SERVICE INFORMATION BULLETIN

Bulletin: 98-11-03

Subject: MAIN HVAC DRAIN TUBE DUCKBILL (KAZOO)

Models Affected: VEHICLES WITH VIN 178369 AND ABOVE

Figure 1: Drain Tube Kazoo Location.

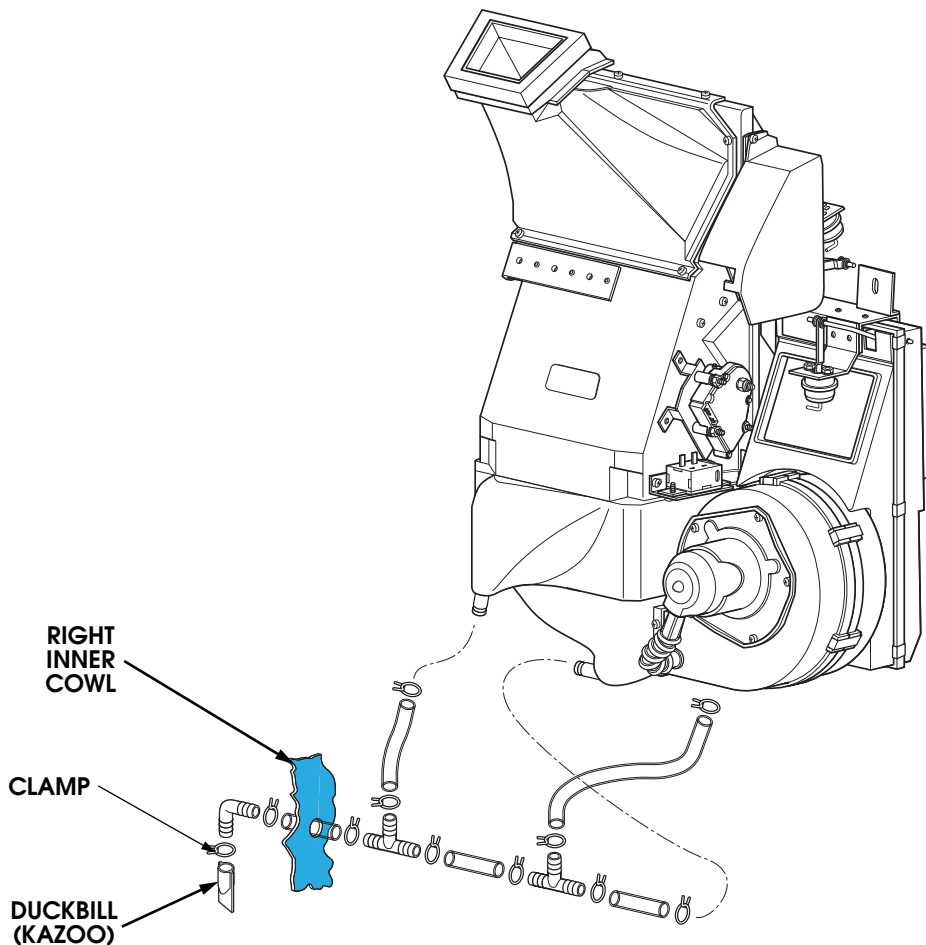
Starting with VIN 178369, vehicles are being built without the kazoo and retaining clamp on the drain tube of the main HVAC unit (See Figure 1). The kazoo has been removed to eliminate the possibility of moisture backing up into the HVAC unit. Leave the drain tube open and do not install a kazoo.
